VALIDATION REPORT

“Samarco Mineração S/A fuel switch project” in Brazil

REPORT NO. 2009-0790

REVISION NO. 01

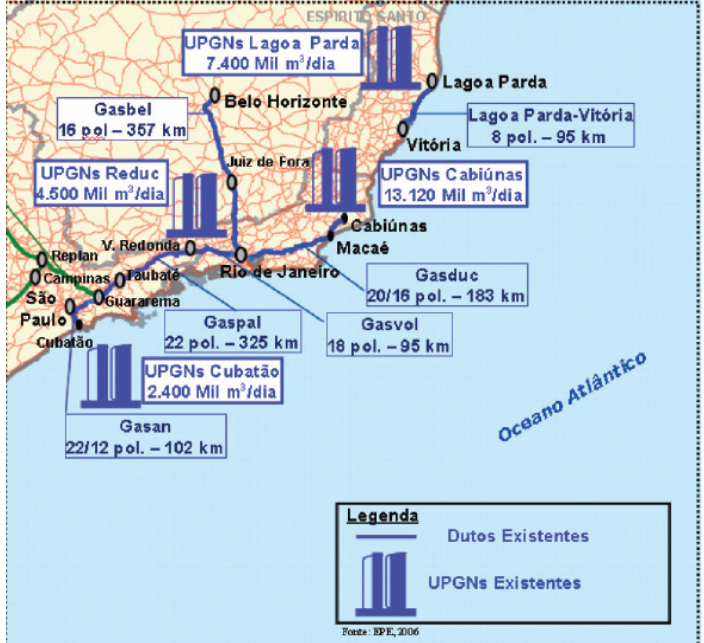
<p>CL 9</p> <p>The NPV calculation should take into account the residual value of the new equipment at the end of the lifetime of the project activity.</p>	B.3.2	<p>The fair-value of the equipments being installed under the project activity is being added back the financial analysis spreadsheet. A 10% constant yearly depreciation rate was applied for calculating the residual value of equipments as per guidance of the Federal Revenue Secretariat (references provided to validation).</p>	<p>The spreadsheet financial analysis SAMARCO v3 evidenced this consideration.</p> <p>Therefore this CL is closed</p>
<p>CL 10</p> <p>It is not clearly justified into PDD how Mineral Coal (kg/TDM) is 0 in the project scenario</p>	B.4.3	<p>Please note that Table 7 (and financial analysis spreadsheet) distinguishes 'Coal in Pellet feed', whose consumption is assumed to be the same in the baseline scenario and in the project scenario for simplicity sake, and 'Coal in furnaces'. Only in the case of "Coal in furnaces", its consumption is assumed as non-existent in the project scenario. This is due</p>	<p>As evidenced by the reviewed PDD and the justification, it was clarified that the difference between the coal for pellet composition, and coal for heating the endurance furnace. Only this last is</p>

Draft report clarifications and corrective action requests by validation team	Ref. to table 2	Summary of project owner response	Validation team conclusion
		to the fact that natural gas will main source of energy in the pelletizing process (not accounting the energy from the coal in pellet feed). Moreover, as a conservative measure, we have assumed that 20% of the energy in the pelletizing process (not accounting the energy from the coal in pellet feed) will be supplied by RFO (backup).	object of project. Therefore this CL is closed.
<p>CL 11</p> <p>Although the estimation of CERs appears to e conservative considering the equivalent energy efficiency of furnaces with fuel oil and gas, for estimation purpose the manufacturers' specification should be used or it needs to be demonstrated that efficiency of the elemental process will not change due to fuel switch or that changes will be negligible (methodology).</p>	B.5.2	<p>PP's apologize for any confusion caused. The statement that "energy efficiency for the processes fired with natural gas is higher to that situation in which coal and RFO are combusted" is not necessarily true. As stated, in the PDD "efficiency was/will be calculated as the ratio resulting of the subtraction of the total energy inputs minus thermal losses divided by total energy input. These parameters, in turn, were calculated according to the enthalpy of the chemical reactions taking place during the induration process (fuel oxidation, formation of $\text{CaO.Fe}_2\text{O}_3$, $2\text{CaO.Fe}_2\text{O}_3$ and CaO.SiO_2, oxidation of magnetite and oxidation of FeO from goethite, degradation of goethite and calcination of carbonates), the heating of the exhausted gases, the heating of the pellets and the vaporization of water. Such calculations are based on the monitored chemical composition and net calorific values of the fuels, on the chemical composition of the pellet-feed, raw pellets and indurated pellets and on the typical temperatures, flow rates and chemical composition of the exhausted gases. Other operational parameters, such as the average mass ratio between iron ore input and indurated pellet production (dry basis), the average mass ratio between raw pellets and indurated pellets, indurated pellet production, cool air intake and its moisture content are also taken into account". Hence efficiency is influenced by a plethora of other parameter not necessarily related to the oxidation efficiency of fuels (related to the statement that "energy efficiency for the</p>	<p>As evidenced by the reviewed PDD and the justification, it was clarified that the same endurance furnace efficiency fuelled with natural gas and with coal/RFO was considered only for baseline estimation, the actual efficiency will be considered into the monitoring plan.</p> <p>Therefore this CL is closed</p>
